OGLE PETROLEUM INC.

RE: Bison Basin Project
Docket No. 40-8745
Source Material
License SUA-1396

Subject: Change in Mining Sequence

Fig. 3.7. Location map of aquifer tests. Source: EP, Fig. 2.6-1.

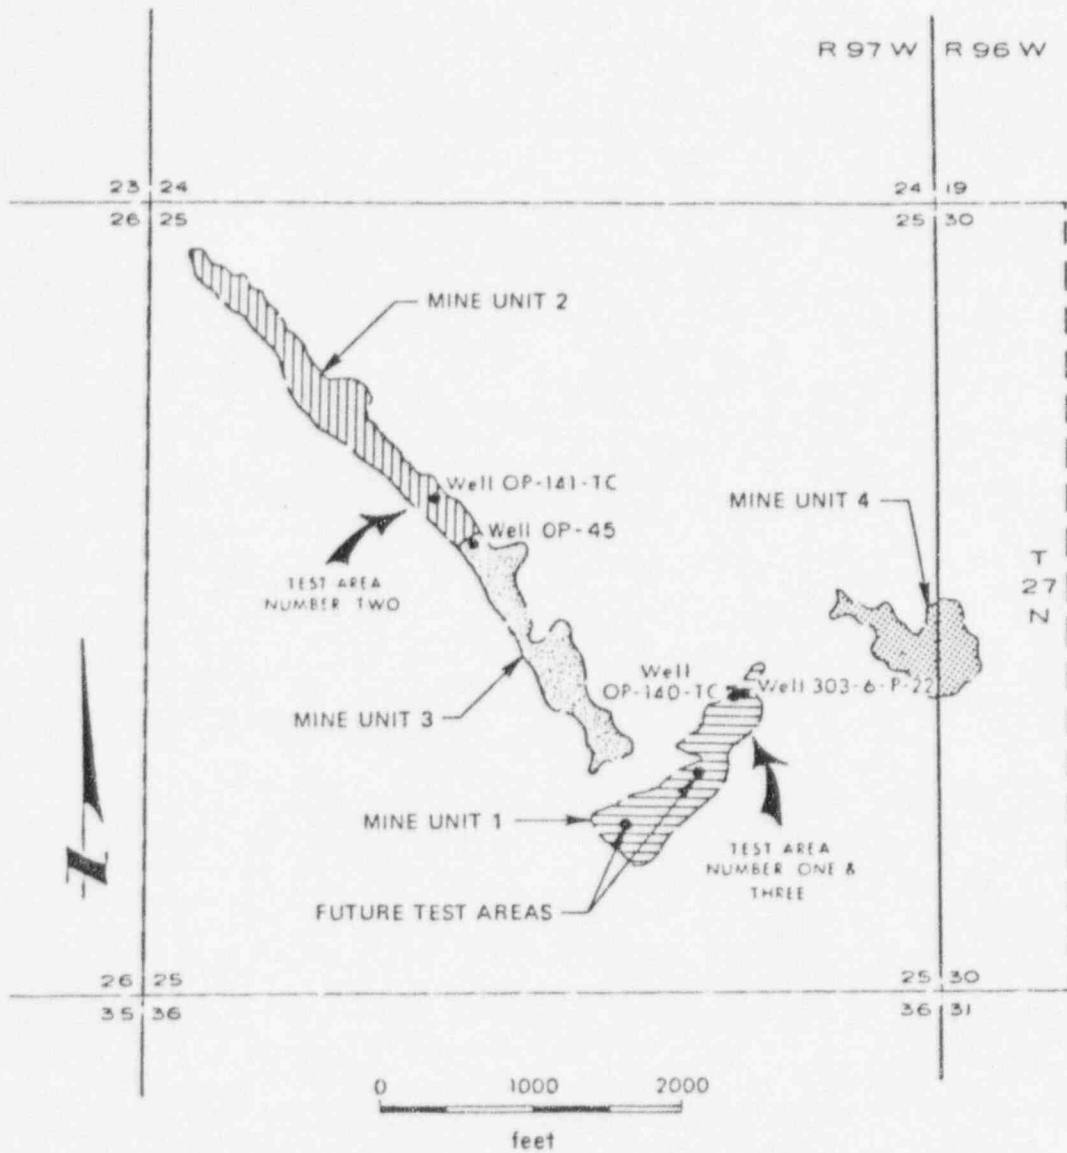
Ogle Petroleum Inc. (OPI) herewith requests an amendment to the above reference license to provide for a minor change in its approved mine plan. A check in the amount of \$760.00 to cover the minor environmental amendment request fee is enclosed. A copy of Figure 3.7 of the Bison Basin FES showing the presently approved mine plan is included with this letter as Attachment 1.

The present mine plan shows OPI jumping from the southeast portion of the orebody (Mining Unit No. 1) all the way up to the northwest part of the orebody (Mining Unit No. 2). Instead of making a leap over Mining Unit No. 3, OPI requests approval of a change in the mining sequence that will allow Mining Unit No. 3 to be the second unit to be mined, and Mining Unit No. 2 to be the third unit to be mined. Stated another way, Mining Unit No. 3 would become Mining Unit No. 2, and Mining Unit No. 2 would become Mining Unit No. 3. This change in the sequence is reflected in the enclosed revised mine plan map (Figure 15-6). No additional acreage to the orebody is being requested and the orebody outline is unchanged. A revised aquifer restoration map (Figure 17-1) is also included with this letter.
